Motion of Support – SWLRT DEIS Comments

RE: Southwest Transitway Draft Environmental Impact Statement

The following comments were approved by the North Loop Neighborhood Association board on November 28, 2012.

6th Ave Streetscape: At-Grade LRT with Integrated Pedestrian Route

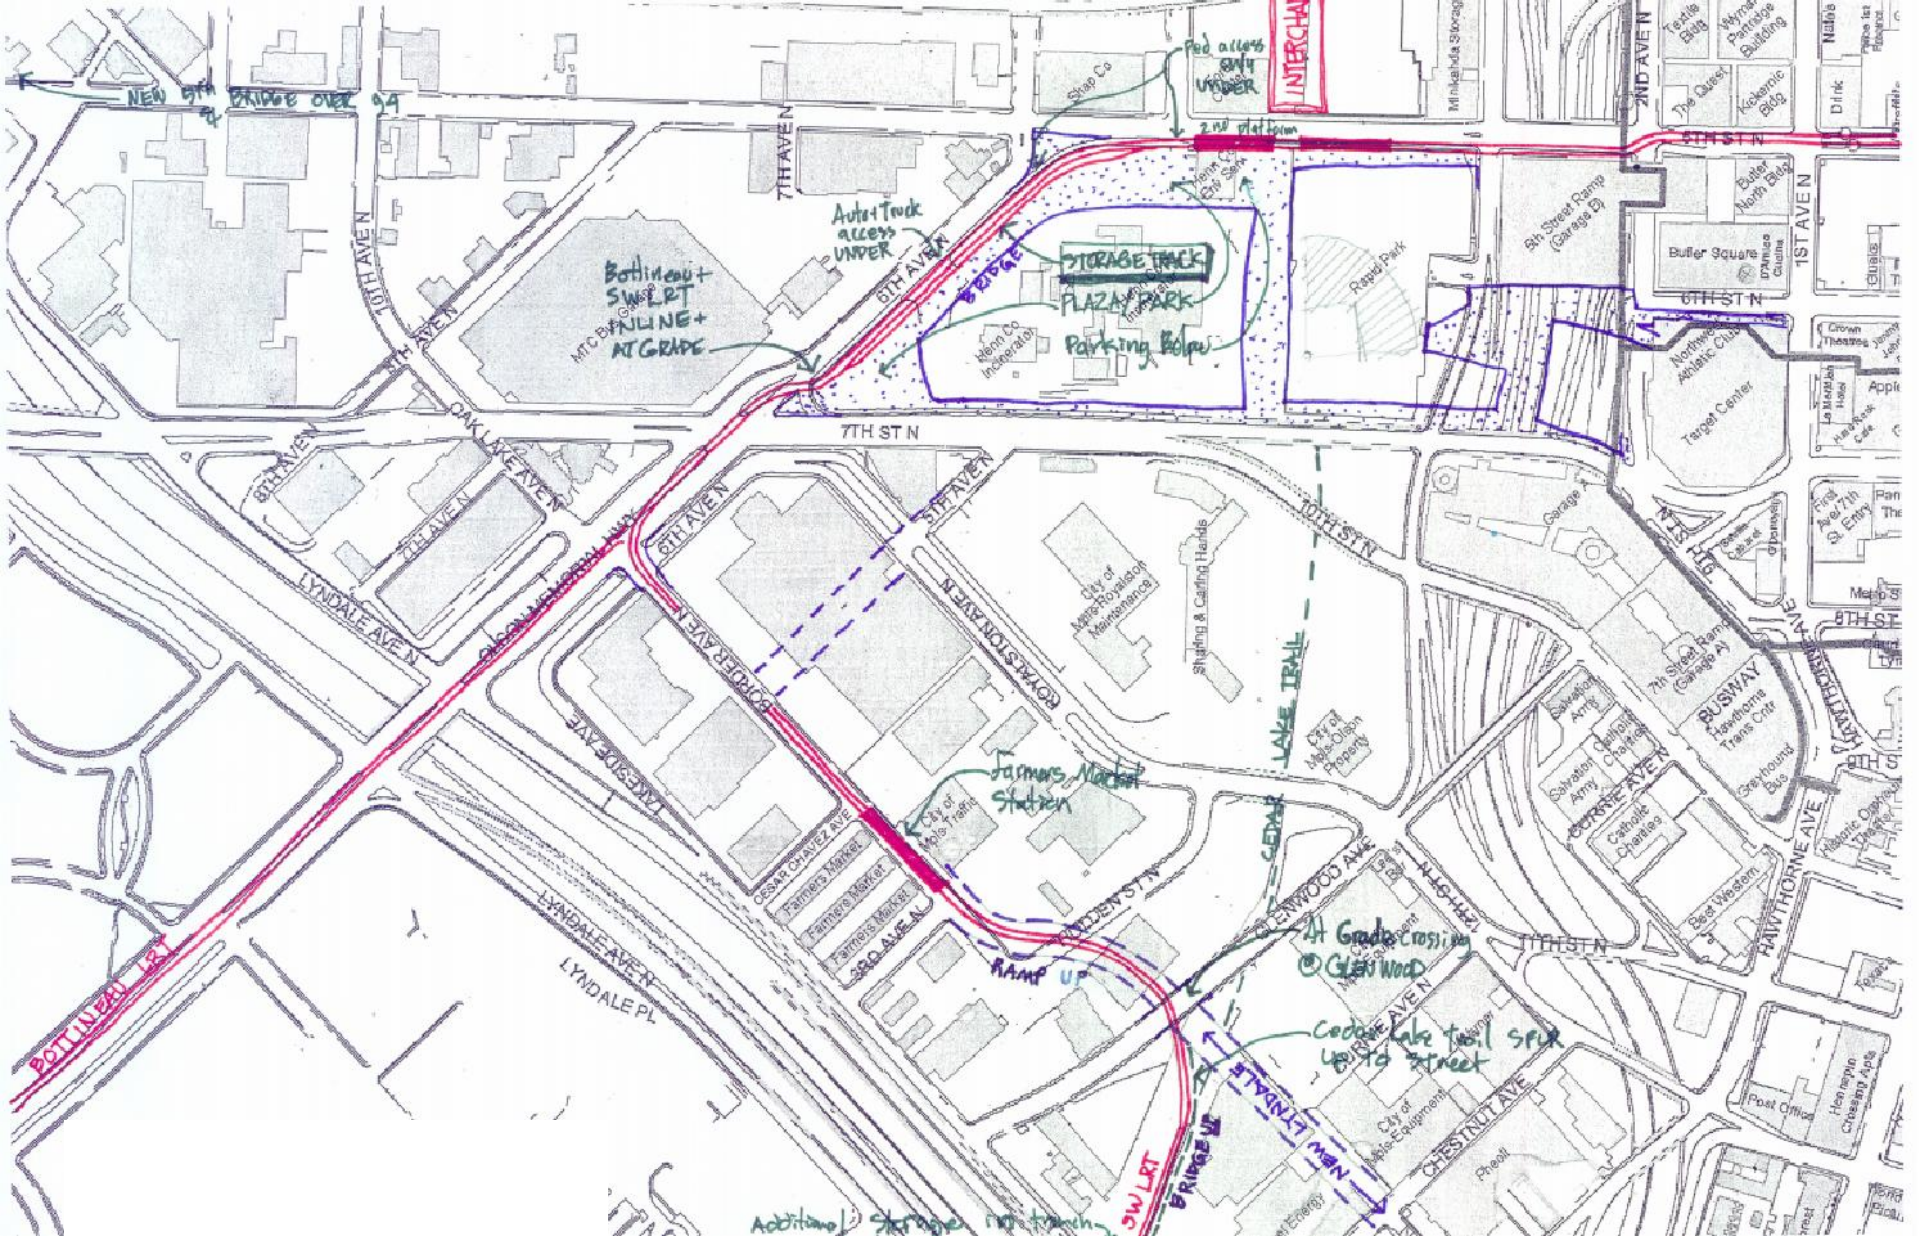
Proposal: Provide street grade LRT at the Royalston alignment as it crosses 7th Street, not within a tunnel or elevated on a bridge. This is in support of the City of Minneapolis' North Loop Small Area Plan, as adopted in the City's Zoning policy. (Refer to attached renderings for an at-grade crossing specifically drafted for this location.)

Issue: The locally preferred alternative routes the Royalston Station along Royalston Avenue. The route should be aligned on Border Avenue.

Outcome: The street grid should be made continuous as outline in the North Loop Small Area Plan. Healing the street grid will improve access to the Transitway and the station. The border Alignment aids this positive street grid access. (Refer to attachment for illustration.) Holden Avenue is proposed to be closed on 6-20 (6.2.2.2) affecting the street grid.

<p>Proposal: Provide route along Border Avenue alignment as shown in the attachment.</p>
